DEVELOPMENT REVIEW BOARD REPORT

CASE NUMBER/ PROJECT NAME	25-DR-2006 Retail / Office Building		
LOCATION	4501 North Scottsdale Road		
REQUEST	Request approval of site plans, elevations, and landscape plan for a office/retail building.		
OWNER	Triyar Management 602-748-8888	ENGINEER	Metro/land Consultants LLC 602-393-2030
ARCHITECT/ DESIGNER	John Reddell Architects Inc 480-946-0242	APPLICANT/ COORDINATOR	John Reddell John Reddell Architects Inc 480-946-0242

Stipulations for Case: Retail / Office Building 25-DR-2006

BUS SHELTER DESIGN

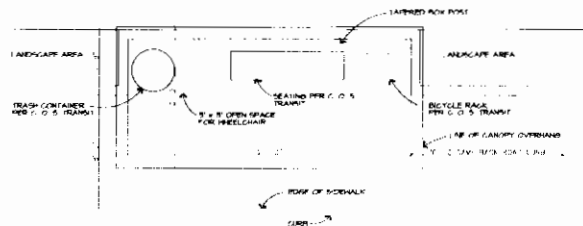
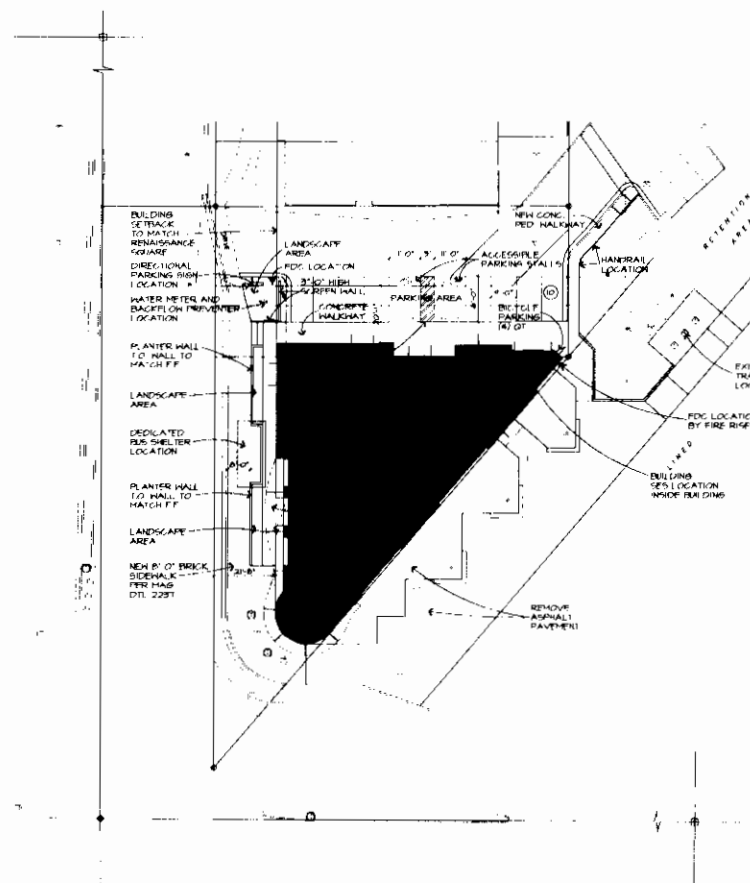
10. All walls shall match the architectural color, materials and finish of the building(s).
11. The bus shelter shall comply with the elevations provided by John Reddell Architects, Inc.

CONCEPTUAL PLANTING PLAN

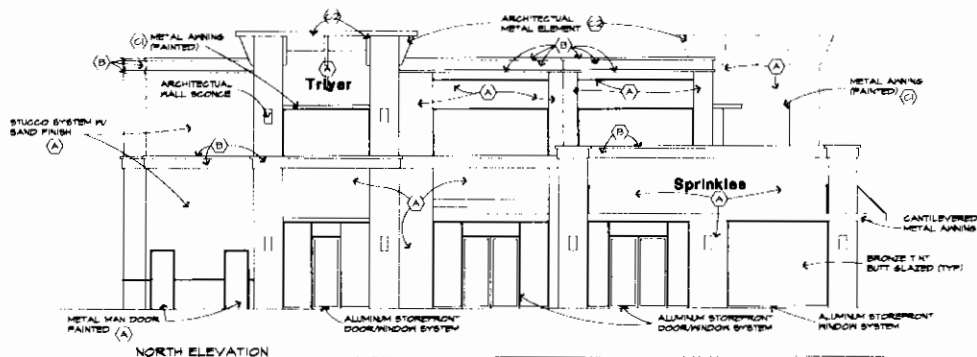
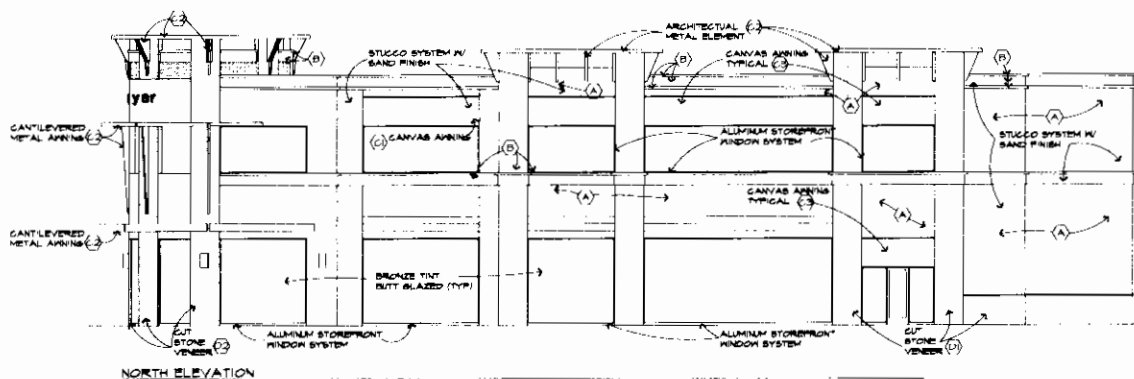
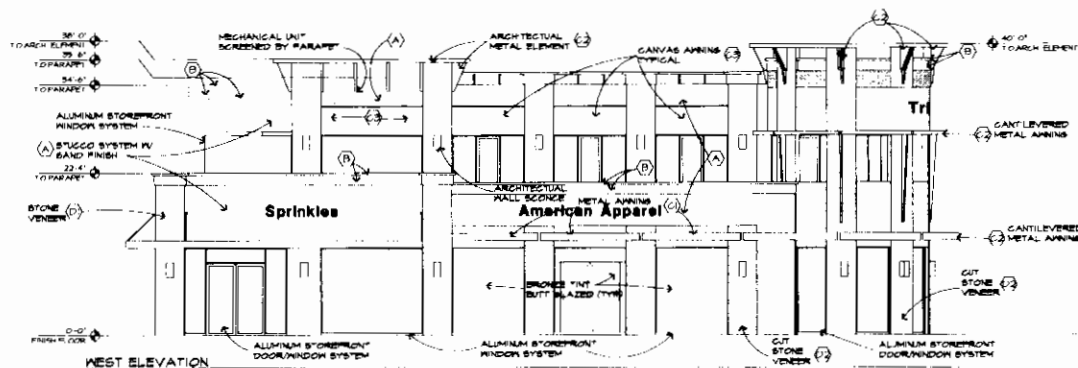
- 14. *Trees adjacent to Scottsdale Road shall be Acacia Smalii.*
- 15. *The shrubs and ground cover adjacent to North Scottsdale Road shall incorporate the shrubs and ground cover species utilized on the east side of North Scottsdale Road in front of the The Renaissance retail center.*
